# Town of Brewster Planning Board

## AMENDED PLANNING BOARD MEETING AGENDA

April 12, 2023 at 6:30 PM

**TO:** Planning Board  
**FROM:** Jon Idman, Town Planner  
**RE:** Major Stormwater Permit SWMP23-10  
5 Tanglewood Road (Map 73 Parcel 86)  
Applicant, M/M Brondyk c/o JM O'Reilly & Associates, Inc.  
**DATE:** March 29, 2023

**SITE PLAN - STORMWATER DESIGN**  
5 TANGLEWOOD ROAD, BREWSTER, MA ASSR'S MAP 73, PARCEL 86

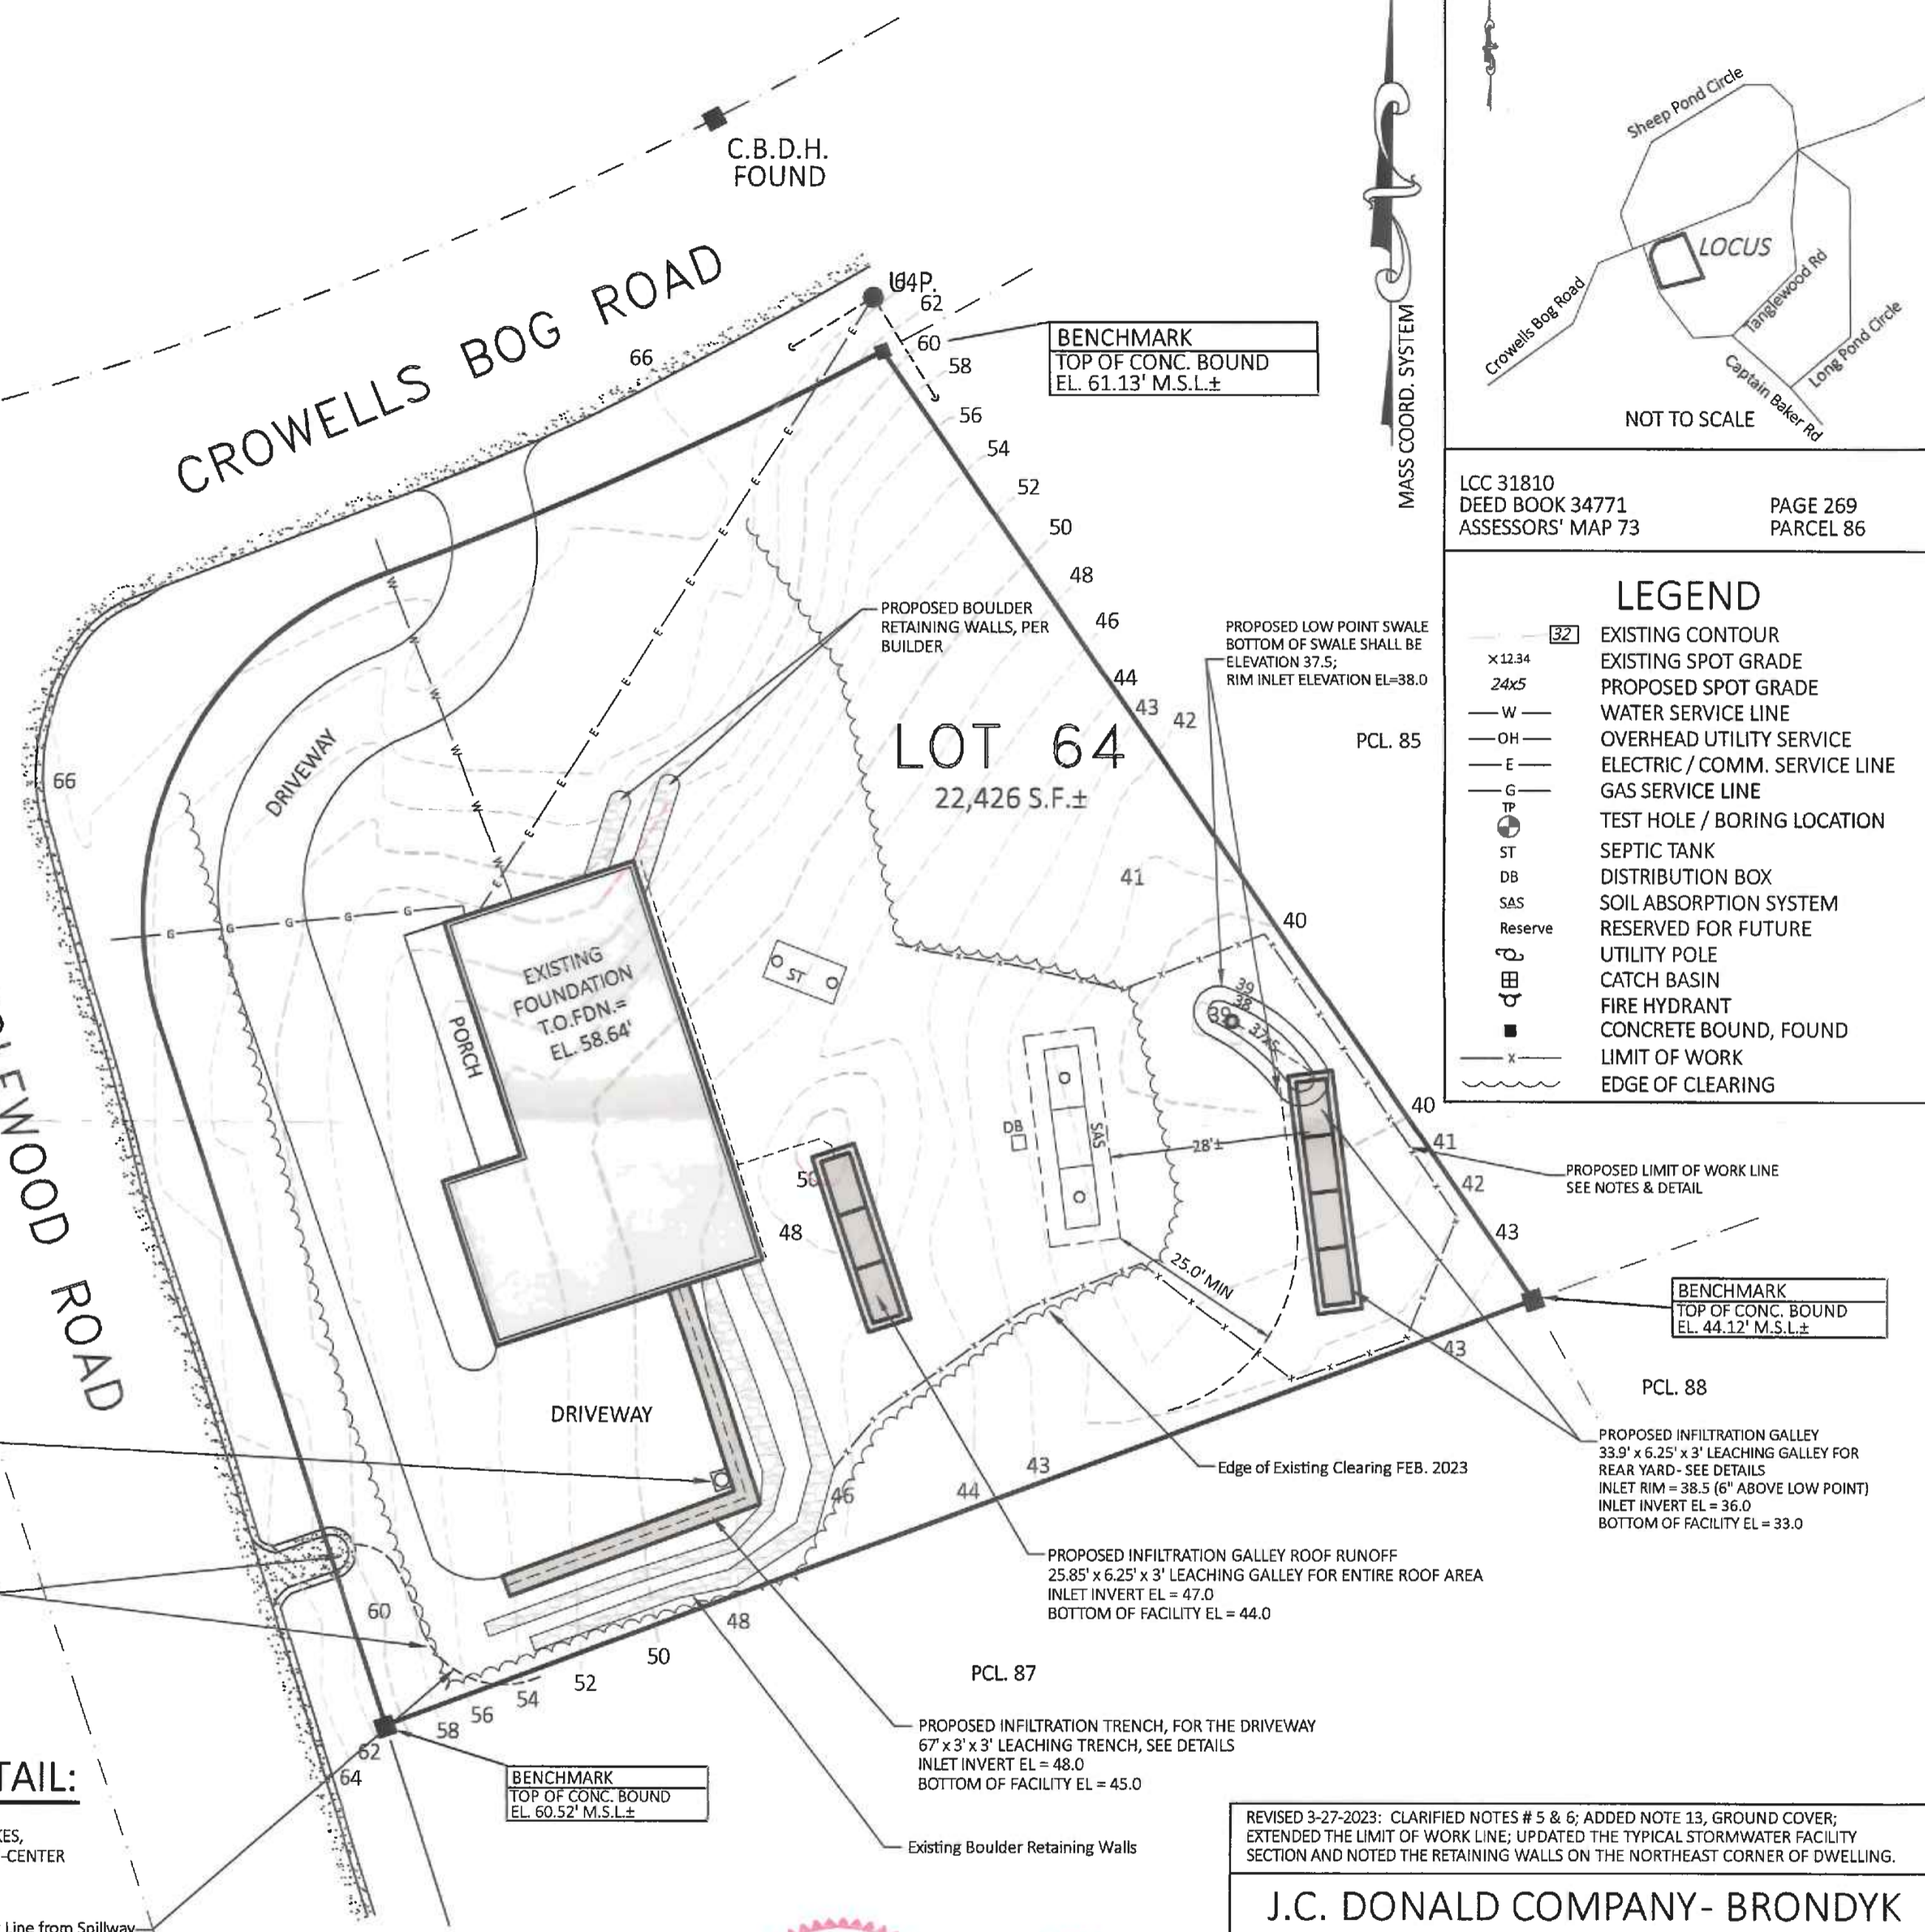
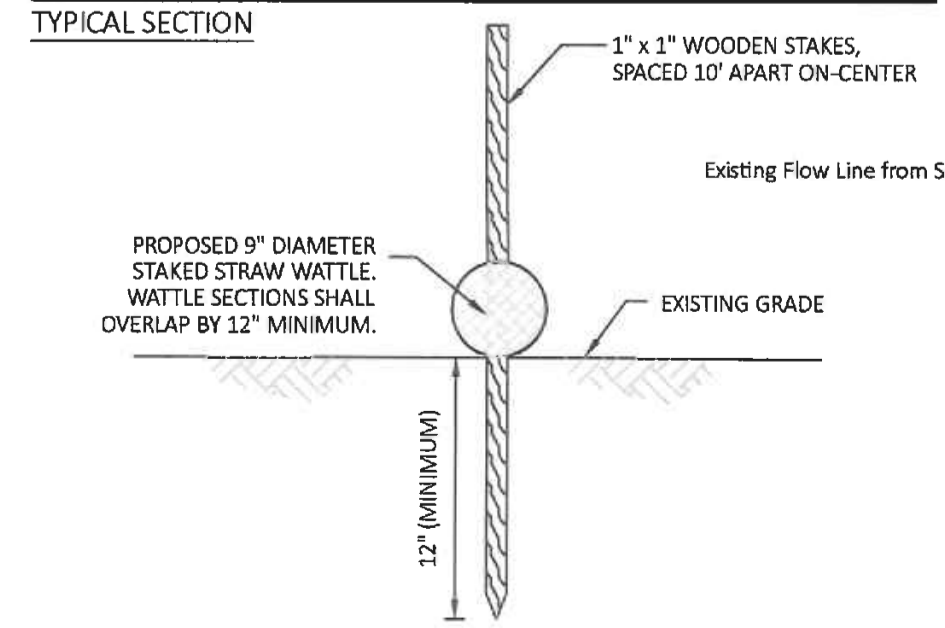
The Applicant has provided the required application materials for a Major Stormwater Permit, including a site plan (revised 3/27/23) and Stormwater Management and Hydrologic Report (dated/ stamped 3/22/23), as set out in Appendix B of the Stormwater Management Regulations.

- Proposed Site Plan entitled "J.C. Donald Company- Brondyk, 167 Cranberry Highway, Orleans, MA 02653, Site Plan- Stormwater Design, 5 Tanglewood Road, Brewster, MA, Assr's Map 73, Parcel 86," prepared by JM O'Reilly & Associates, Inc., revised dated 3/27/23 and stamped by John M. O'Reilly, PE, PLS.

The Applicant has provided construction-period BMPs in an erosion and sedimentation control plan consistent with the performance standards for Major Stormwater Permits set out in Section 6.1B of the Stormwater Management Regulations. Plan elements include straw wattles, a gravel construction drive and protection of catch basins.

The post-construction stormwater management system for the site consists of three separate stormwater management subsystems/ catchment areas. Roof run-off will be collected separately from site run-off, then directed to one of the subsurface leaching facilities for recharge. Run-off from the gravel driveway will be collected from sheet flow, then directed to a gravel infiltration trench. Finally, run-off towards the rear of the site will be collected by sheet flow, directed to and treated in the vegetated water quality swale then conveyed to a subsurface leaching facility separate from the one for the roof run-off. The Applicant has provided a corresponding Operations and Maintenance Manual. These post-construction BMPs are consistent with the Major Stormwater Permits performance standards for new construction set out in Section 6.2B and Section 8.2 of the Stormwater Management Regulations:

- As designed, post-development runoff rates are reduced to less than the pre-development conditions including for the 100-year storm.
- The O&M plan deals with long term maintenance of all post-construction BMPs such as the subsurface recharge system and water quality treatment swale.

Approval should be granted subject to the continuing obligations set out in said Regulations, including Sections 5.7, 5.8, 5.9 (Certificates of Compliance), 6.1B (Construction practices), Section 7.2 (Inspections), 8.3 (Recording of stormwater permit and O&M plan) and 8.5 therein.

**PLAN**  
SCALE 1"=20'  
THIS AREA IS SERVED  
BY TOWN WATER.

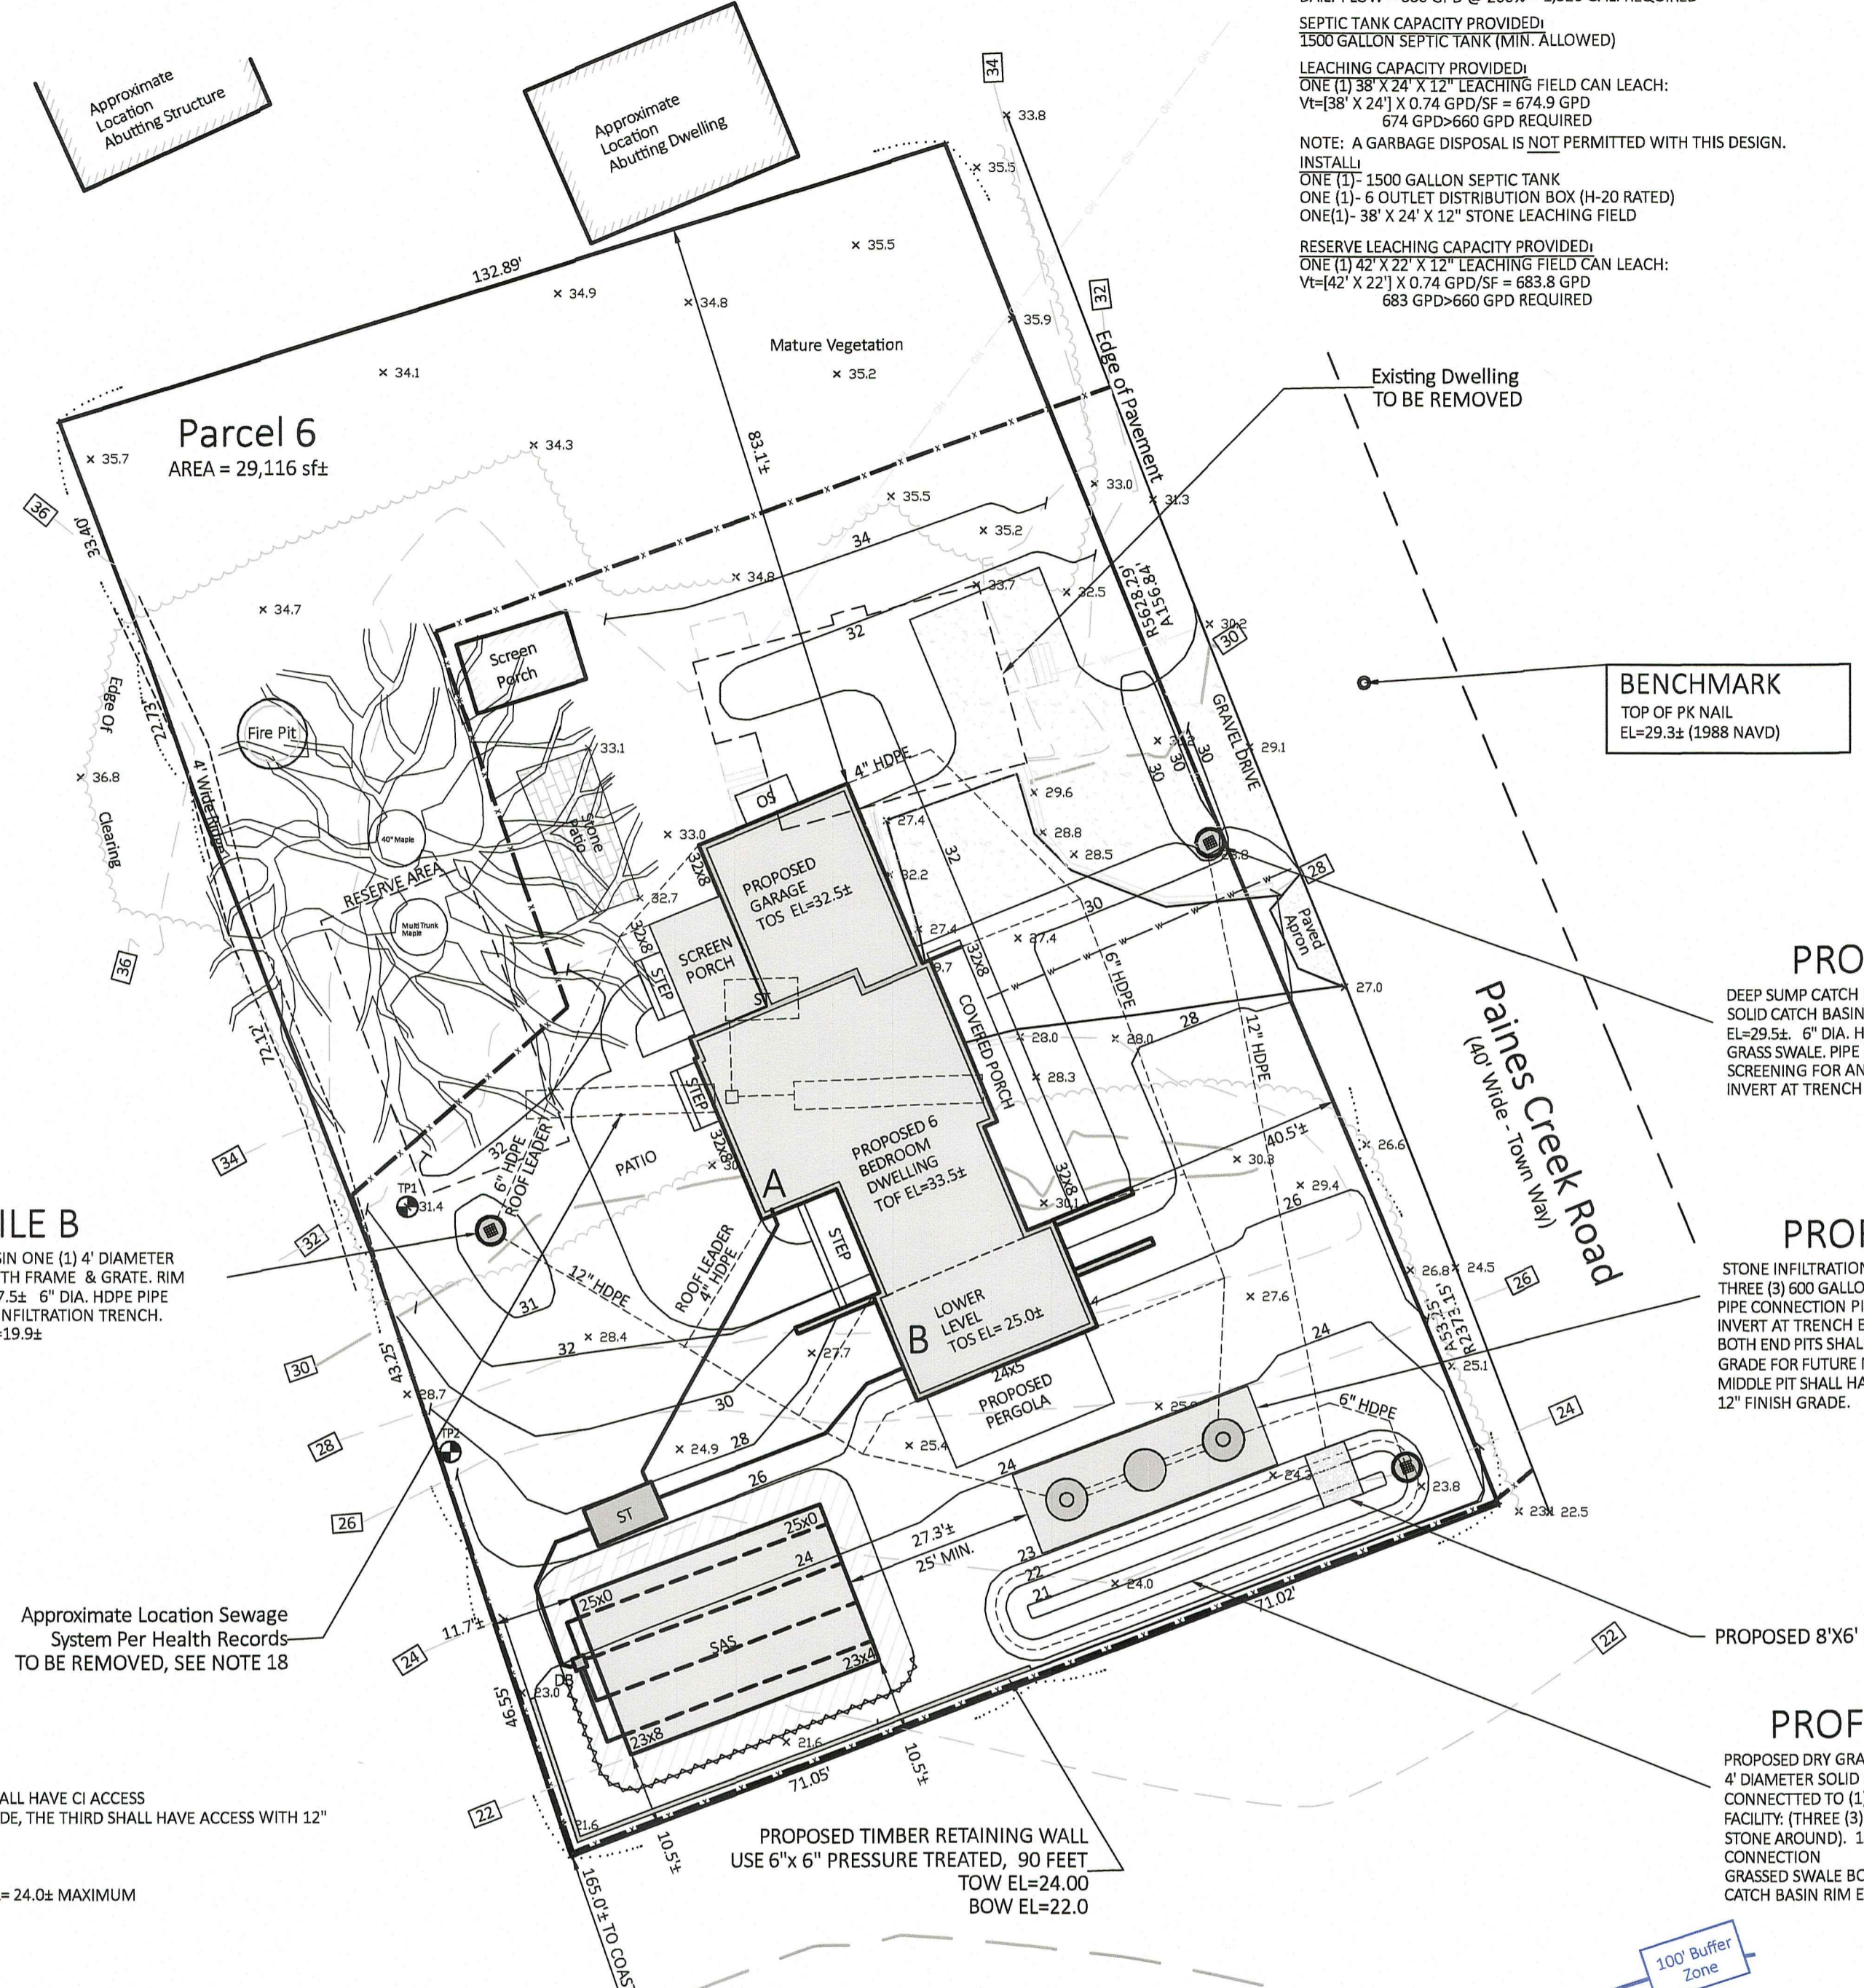
The Applicant has provided the required application materials for a Major Stormwater Permit, including a site plan and Stormwater Management and Hydrologic Report (revised dated 3/31/23), as set out in Appendix B of the Stormwater Management Regulations.

- Proposed stormwater site plan entitled "Sharon Residence, c/o Jim Hagerty, Reef, Cape Cods Home Builder, PO Box 186, Dennis, MA 02670, Proposed Site & Sewage Disposal System Design, 393 Paines Creek Road, Brewster, MA," prepared by JM O'Reilly & Associates, Inc., revised dated 3/31/23 and stamped by John M. O'Reilly, PE, PLS.

The Applicant has provided construction-period BMPs in an erosion and sedimentation control plan consistent with the performance standards for Major Stormwater Permits set out in Section 6.1B of the Stormwater Management Regulations. Plan elements include straw wattles, a gravel construction drive, erosion control blankets as needed and protection of catch basins or other stormwater facility inlets.

1. The run-off from the easterly portion of the roof will be directly piped to the leaching chambers.
2. Sheet-flow from the gravel driveway will enter a catch basin and then will be piped to the grass swale via rip rap. There is a catch basin in the swale that will then convey run-off to the leaching chambers.
3. Run-off from the westerly portion of the roof will be piped to a catch basin in the western portion of the site along with other run-off from the westerly portion of the site, and will then be piped to the leaching chambers.
4. The swale will also pick-up sheet flow from the rear/ south portion of the site, which will then be conveyed through a catch basin to the leaching chambers.

- As designed, post-development runoff rates are reduced to less than the pre-development conditions including for the 100-year storm.
- The O&M plan deals with long term maintenance of all post-construction BMPs such as the subsurface recharge system and water quality treatment swale.

Approval should be granted subject to the continuing obligations set out in said Regulations, including Sections 5.7, 5.8, 5.9 (Certificates of Compliance), 6.1B (Construction practices), Section 7.2 (Inspections), 8.3 (Recording of stormwater permit and O&M plan) and 8.5 therein.
